**COUNTY OF SAN MATEO
PLANNING AND BUILDING DEPARTMENT**

SUBJECT: Consideration of the adoption of an Initial Study/Mitigated Negative Declaration, pursuant to the California Environmental Quality Act (CEQA), and a Design Review Permit and Coastal Development Permit, pursuant to Sections 6565.3 and 6328.4 of the County Zoning Regulations, and a Merger, pursuant to Section 7123 of the Subdivision Regulations, to allow construction of a new two-story, 1,971 sq. ft. residence with a 1,015 sq. ft. attached garage on a 5,643 sq. ft. legal parcel on Cypress Avenue, in the unincorporated Moss Beach area of San Mateo County. The project is appealable to the California Coastal Commission.

County File Number: PLN2020-00070 (Love/Mukaeda)

First Floor Electrical
Plan

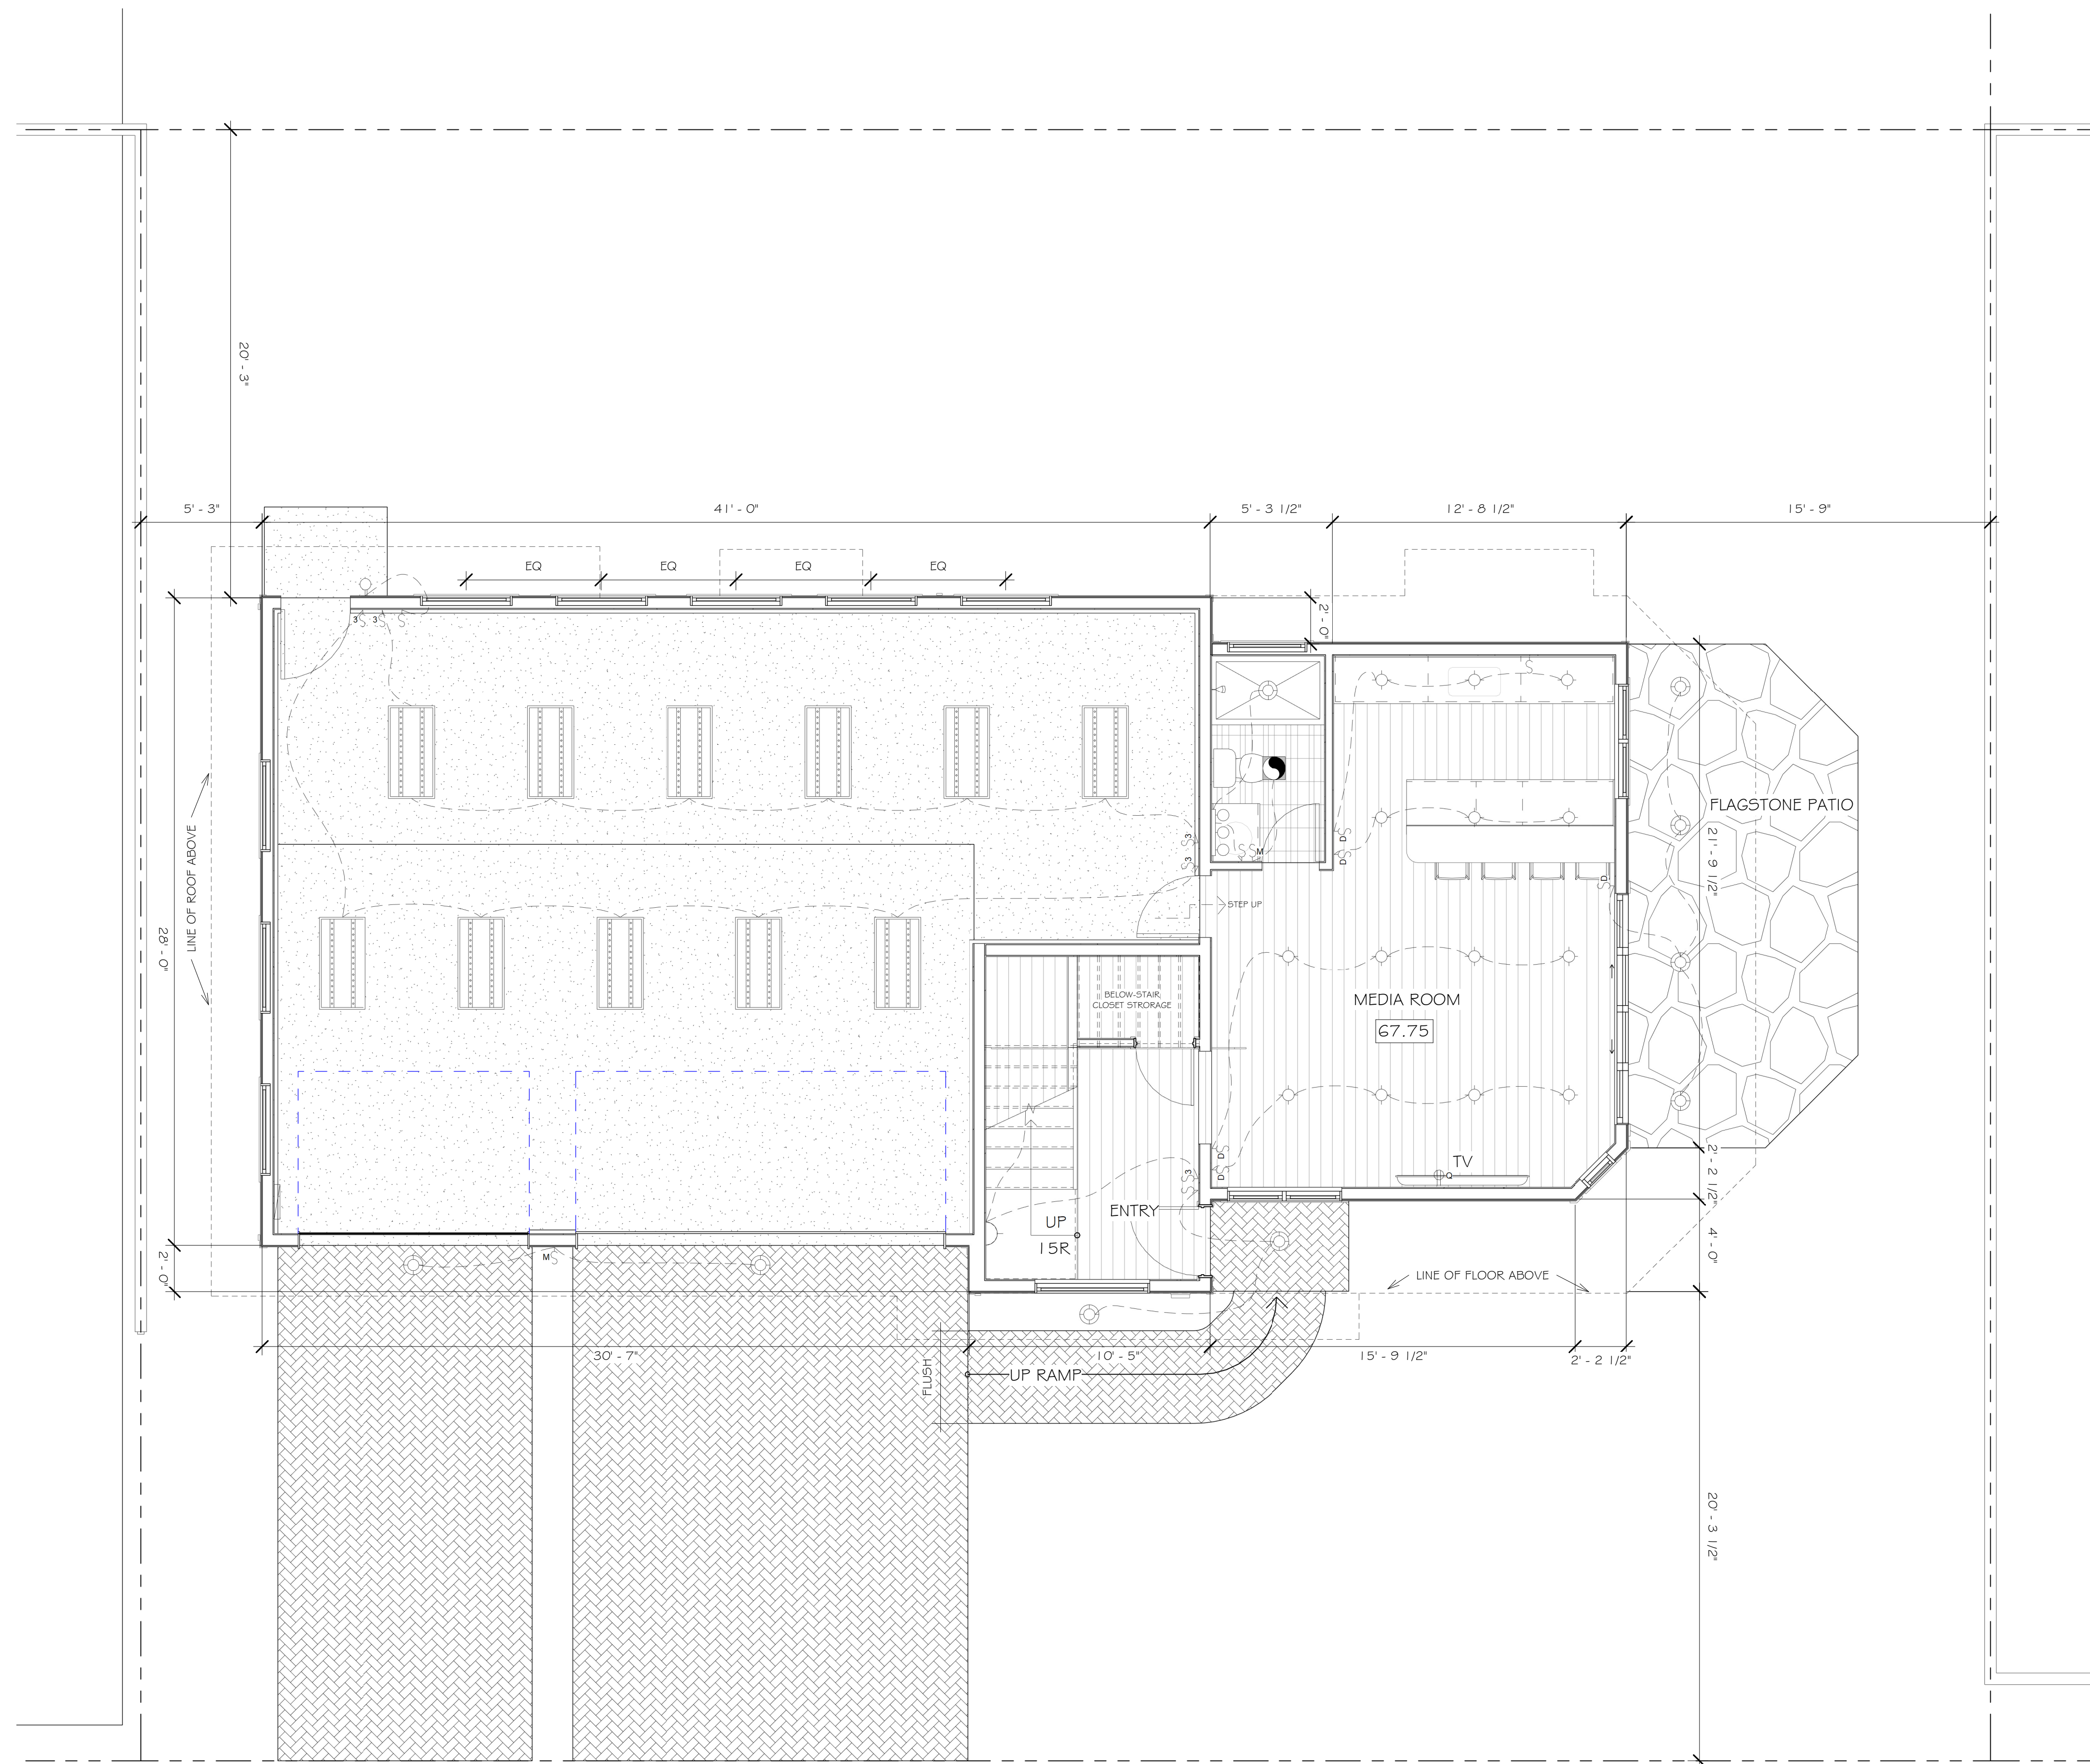
- c. Section 6565.20.F.4 (LANDSCAPING, PAVED AREAS, FENCES, LIGHTING AND NOISE: Lighting), the applicant shall remove two of the four recessed lights proposed at the “Flagstone Patio” as shown on sheet E102.
